SEWAGE DISPOSAL SYSTEM
HOWARD COUNTY HEALTH DEPARTMENT
BUREAU OF ENVIRONMENTAL HEALTH
410-313-2640

A REPAIR

SUBDIVISION _____ LOT NUMBER _____ ADDRESS 13855 Brighton Dam Road

REPAIR - PURPOSE - Existing septic system has failed.
Call for inspection when ground is opened so sanitarian can recommend repair. 3/14/01

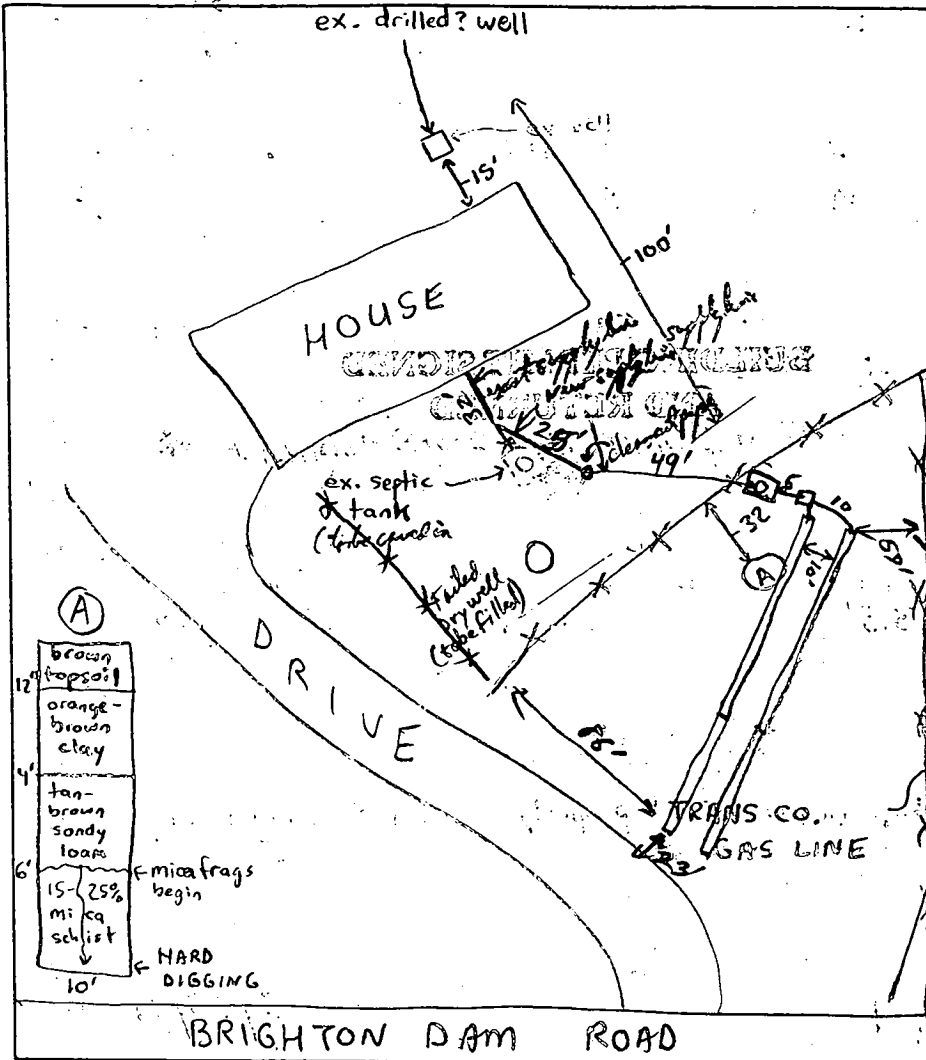
PRE-CONSTRUCTION INSPECTION: 3/15/01 - MET INSTALLER AT SITE, DUG PERC HOLE IN LOCATION (A) (SEE

SOIL PROFILE) OK TO INSTALL 2 (90' TRENCHES) ON CONTOUR, SETTING NEW DBOX AND TANK, ALSO

ABANDON AND SEAL EX. SYSTEM, TRANS. CONTINENTAL GAS LINE AND EASEMENT, MARKED - (SEE

INSPECTION COMMENTS: Lid removed from dry well (cave in), being pumped. will be filled in

Manhole (metal) in center of ST. (1" Baffle in ST. OK); Dirt Box (Zeller plastic. Multibaffle) with decorative pipe on top (buried). Trenches OK to cover. OK to cover all work. 4/3/01

SITE PLAN

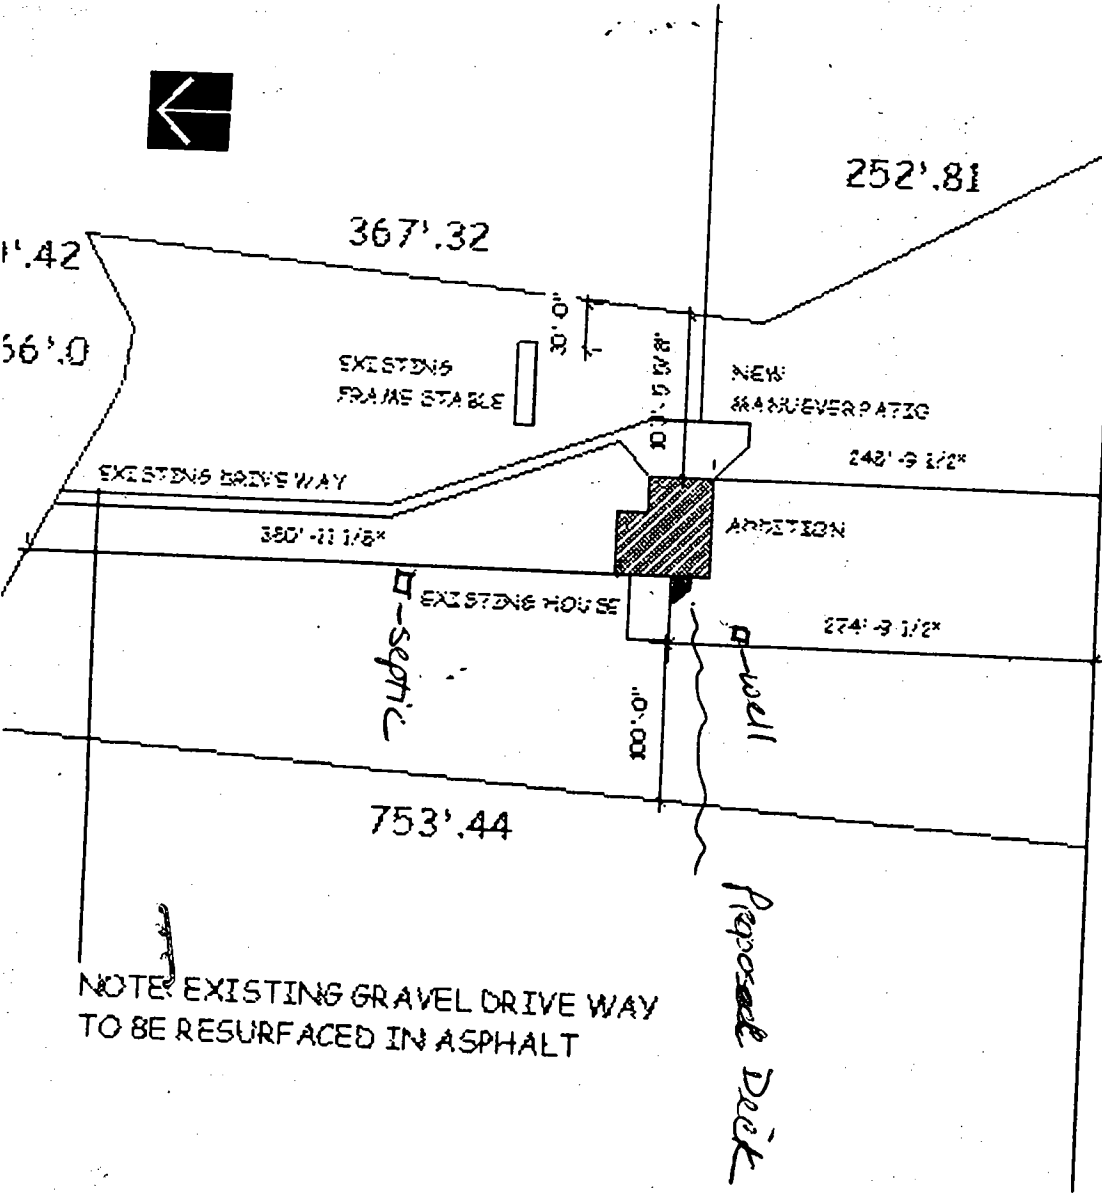
We are adding a bedroom in addition and demolishing bedroom in existing house

Addition to go where existing garage is now

5/10/04 floor plan for bp. 00147834 shows 3 bedrooms OK KN
